PRODUCT CHANGE NOTIFICATION

Select Bourns® Metal Oxide Varistors *Part Number and Lead Style Change*

Riverside California – December 9, 2022 – Effective immediately, Bourns will update select Bourns® Metal Oxide Varistor (MOV) part numbers to comply with the part number naming rules for our expanded MOV product offering. Bourns will also change the kinked lead style of select Bourns® Metal Oxide Varistors from “Outward” to “In-line” to improve the integrity of tape and reel packing.

MOV Naming Rules

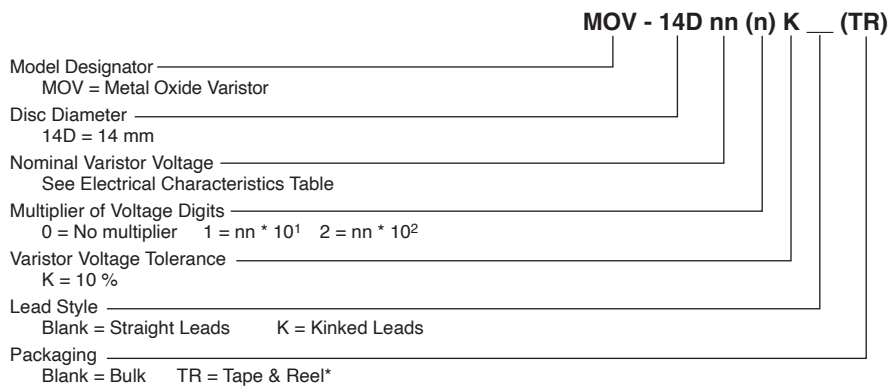
Under the new MOV naming scheme, MOV-14Dnn(n)K, with one “K” at the end, represents the straight leads and MOV-14Dnn(n)KK, with two “KK” at the end, represents kinked leads. Please refer to the complete MOV naming rules provided below for more details.
